Access Compliance Report

Public Rights-of-Way

(Curb Ramps)

Intersection ID: 22470	Main Street: SHARON_VIEW_RD	Cross Street: BENTRIDGE_DR	Location: SE
ADA ID: A6CBE45E3AA6	Ramp Type: PerpDiag	Initial Pass/Fail: Fail	Overall Compliance: No
Severity Score: 13.75			
Codes/Mitigation Info/Possible Solution		Field Measurements/Component Compliance

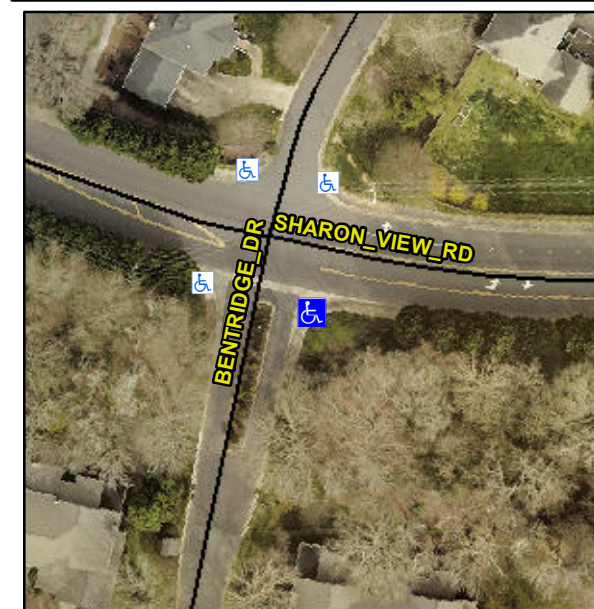
Not Found, R304.2.2, R304.5.3

Compliance	Description	Data	Compliance	Description	Data
N/A	Ramp Length (in)	60.5	No	Ramp Slope (%)	11.3
Yes	Ramp Width (in)	48.0	No	Ramp XSlope (%)	3.4
N/A	Flare Type LT	N/A	N/A	Flare Type RT	N/A
N/A	Flare Slope LT (%)	N/A	N/A	Flare Slope RT (%)	N/A
N/A	Flare Traversable LT?	N/A	N/A	Flare Traversable RT?	N/A
N/A	Landing Length (in)	N/A	N/A	DWS Provided?	N/A
N/A	Landing Width (in)	N/A	N/A	DWS Contrast?	N/A
N/A	Landing Slope (%)	N/A	N/A	DWS Length (in)	N/A
N/A	Landing X Slope (%)	N/A	N/A	DWS Full Width?	N/A
N/A	Landing Curb? (Y/N)	N/A	N/A	DWS Offset (in)	N/A
N/A	Shared Landing?	N/A			
N/A	Gutter Ponding?	N/A	N/A	Gutter Slope (%)	N/A
N/A	Gutter Lip Ht (in)	N/A	N/A	Gutter X Slope (%)	N/A
N/A	Painted X Walk1?	No	N/A	Painted X Walk2?	No
	X Walk 1 Direction	To N		X Walk 2 Direction	To NW
N/A	X Walk 1 Width (in)	N/A	N/A	X Walk 2 Width (in)	N/A
	X Walk 1 Slope (%)	0.1		X Walk 2 Slope (%)	5.0
	X Walk 1 X Slope (%)	5.3		X Walk 2 X Slope (%)	3.5

N/A	Ramp inside XWalk1?	N/A	N/A	Ramp inside XWalk2?	N/A
	Road Slope (%)	4.0	N/A	Clear Space?	N/A
	Road X Slope (%)	7.0	N/A	Clear Space to XWalk (in)	N/A
N/A	Any Obstructions?	N/A	N/A	Storm Grate/Utility Hazard?	N/A
	Obstruction Type			Storm Grate/Utility Type	
		N/A			N/A
		Yes		Surface Condition? (G/P)	Good

Remove & Replace Curb Ramp With Two New Directional Ramps or Equivalent.
